Bulletin No.: 09-07-30-004G

Service Bulletin

Subject: Slips in Reverse or Third, Delayed Reverse or Drive Engagement, DTC P0776, P2715, P2723, Harsh 2-3 Shifts (Inspect 1-2-3-4 / 3-5-R Housing and Pump Seal Rings)

This bulletin is being revised to add first Important statement under Correction and update the Parts Information descriptions. Please discard Corporate Bulletin Number 09-07-30-004F (Section 07 – Transmission/Transaxle).

2715381

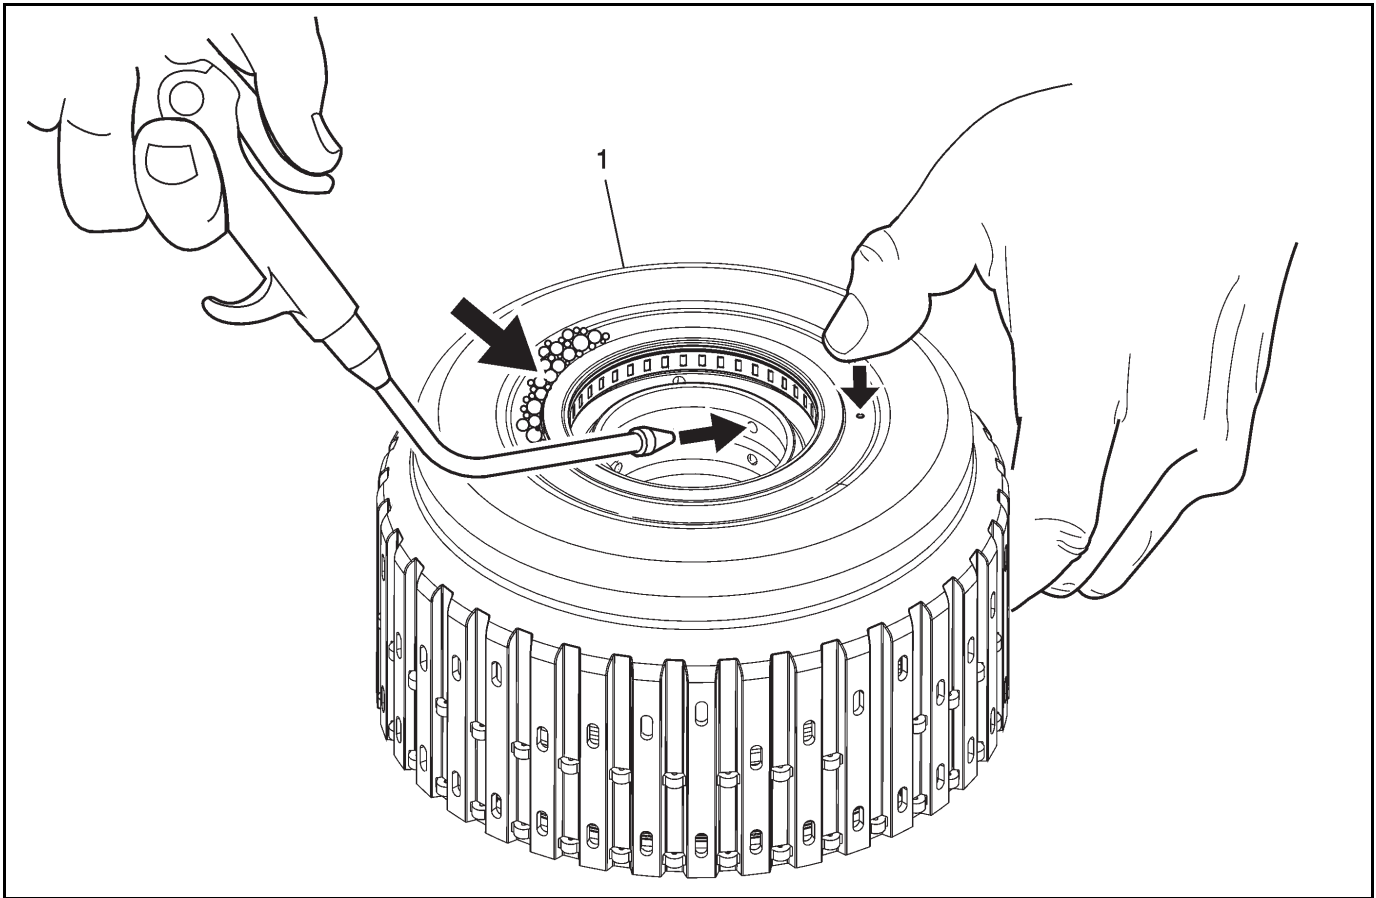
Inspect the 1-2-3-4 / 3-5-R clutch housing for a possible cracked weld. The housing can be inspected either assembled or disassembled.

1. Apply soap compound to the weld area of the housing.
2. Hold your thumb over the air bleed passage.
3. For a fully assembled 1-2-3-4 and 3-5 reverse clutch housing, spray compressed air into the 3-5R clutch feed hole and inspect the weld area for bubbles.
4. If bubbles are detected, a new housing is required.

Important: If a cracked housing is identified, it must be replaced. Complete, assembled 1-2-3-4 / 3-5-R clutch housings are now available. These clutch housings come complete with all pistons, seals, clutches, bearing and internal parts. No assembly of the clutch housing is required before it is installed.

2539550

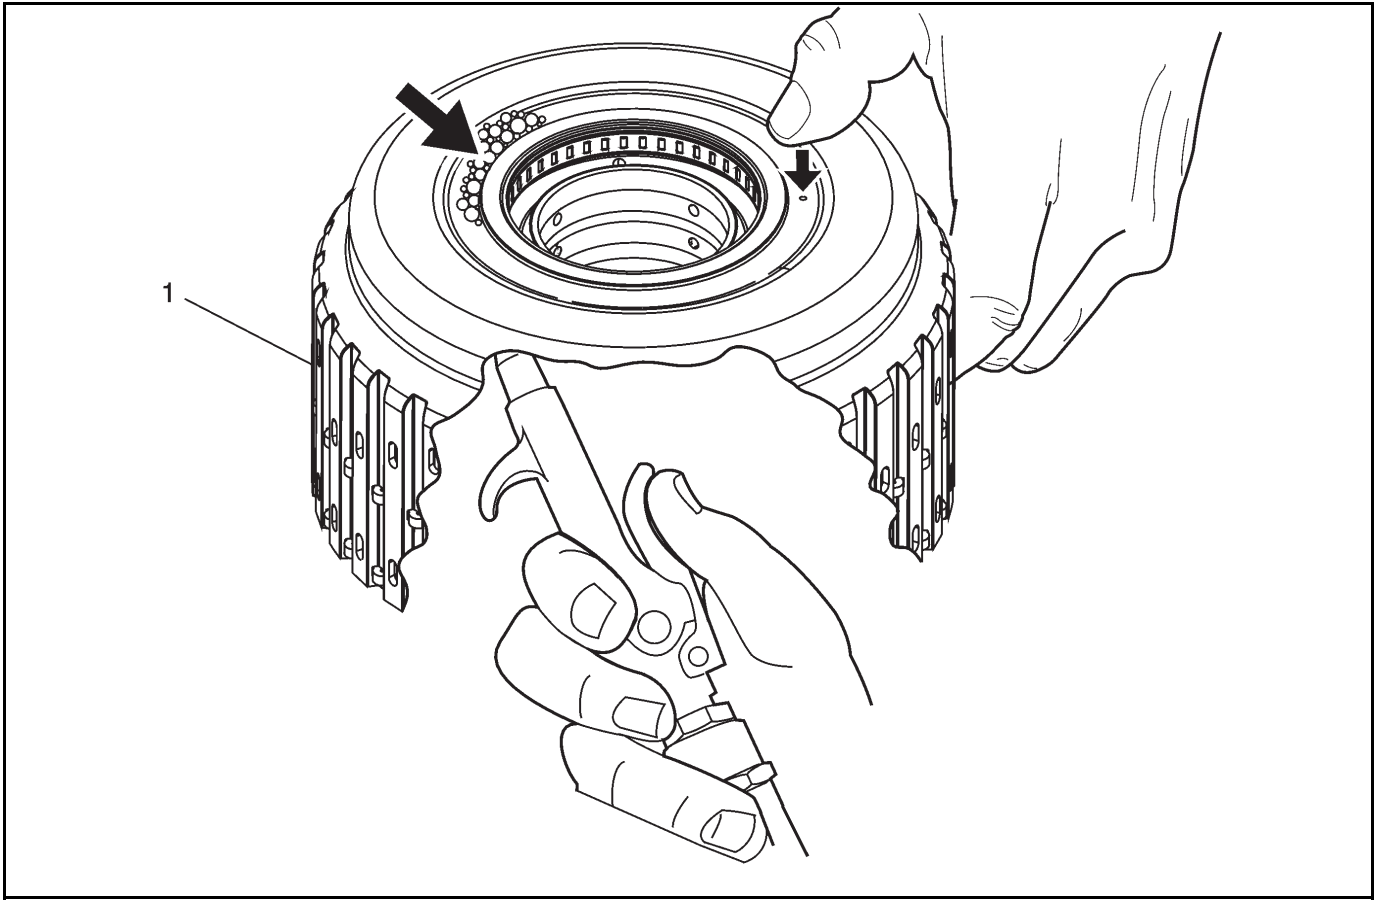
Inspect the 1-2-3-4 / 3-5-R clutch housing for a possible cracked weld.

1. Apply soap compound to weld area of the housing.
2. Hold your thumb over the air bleed passage.
3. Spray compressed air into the housing and inspect the weld area for bubbles.
4. If bubbles are detected, a new housing is required.

2219005

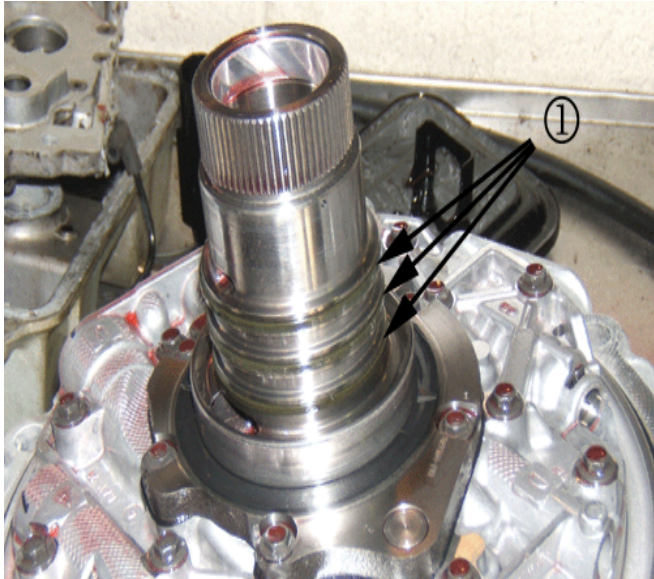
A harsh 2-3 shift condition may be caused by leaking 1-2-3-4 and 3-5-R clutch fluid seal rings (1) on the transmission fluid pump cover assembly.

Inspect the fluid seal rings. Transmissions in 2006, 2007, 2008 and early build 2009 models used a 1-piece design seal ring in production. Starting December 2008, a 2-piece seal ring design was implemented. The 1-piece seal ring design may cause a harsh 2-3 shift due to leakage. This is typically a low mileage issue. If the seal rings are a 1-piece design they should be replaced.

Notice: The three clutch fluid seal rings are required to be installed in a specific way. Failure to install new clutch fluid seal rings in the proper orientation may cause a repeat harsh 2-3 shift. Refer to 1-2-3-4 and 3-5 Reverse Clutch Fluid Seal Ring Installation (6L80/90) in SI for correct installation.

2475192

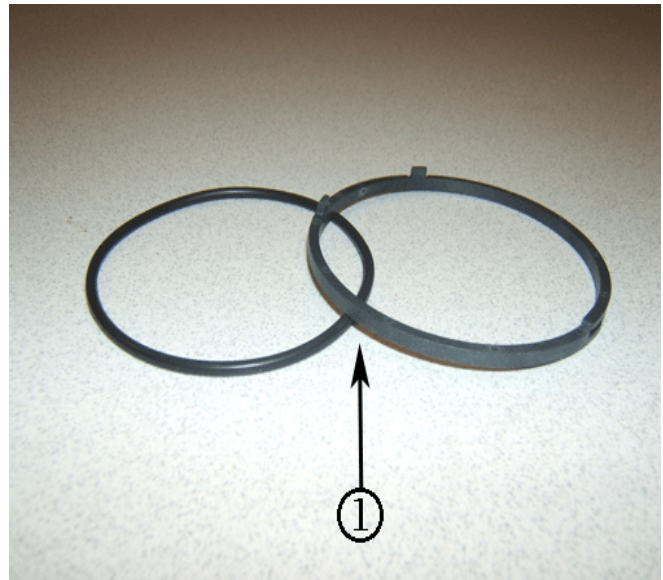
If the seals are the 2-piece design shown below, they do not need to be replaced unless they are worn or damaged.

Important: Do not install 1-piece design seal rings on a 2-piece seal ring design pump cover. The 2-piece seal ring design pump cover can be identified by the notch in the seal ring grooves that accepts the tab on the 2-piece design seal rings.
